## Licensing FAX Coversheet

Message: As we discussed on the phone I have enclosed a DRAFT of the material we intend to present at the meeting scheduled for 6/18/01. This is a work in progress but will give the staff an opportunity to see the material we are developing before the meeting

- **Request for Exemption from 10 CFR 20.1003 Definition of "Deep-Dose Equivalent" and Permission to use External Whole Body "Weighting Factors" Other than 1.0**

- **John J. Kelly, Director - Licensing**
- **Entergy Nuclear Operations, Inc.**
- **X. George Xu, Ph.D., Associate Professor**
- **Nuclear Engineering and Health/Medical Physics**
- **Rensselaer Polytechnic Institute**
- **June 18, 2001**

## Question 9

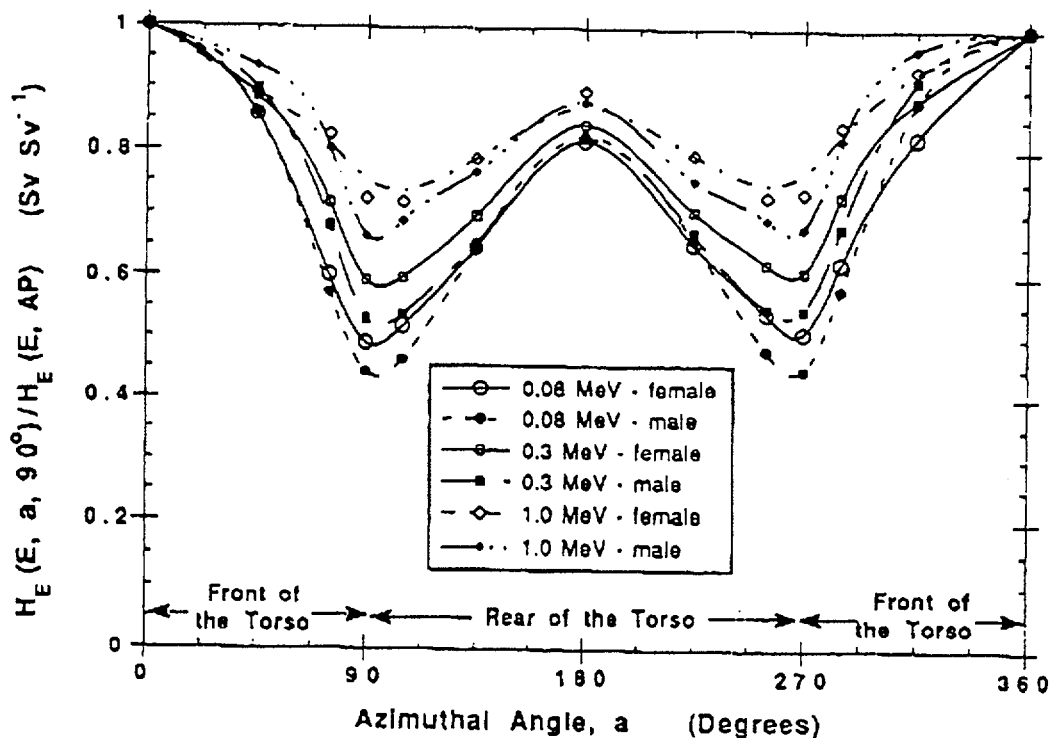
Provide the directional response summary of the dosimeters planned for use and how directional sensitivity will be accounted for.

The dosimeters to be used in the EPRI EDE methodology are the same dosimeters used for compliance with the NRC approved methodology and have the same directional response. A February 1995 article in "Health Physics," (Reference 5.7 of the exemption request<sup>1</sup>) describes the effect of directional response on the EPRI EDE methodology and on the NRC approved methodology.

*See graph on next page for further discussion.*
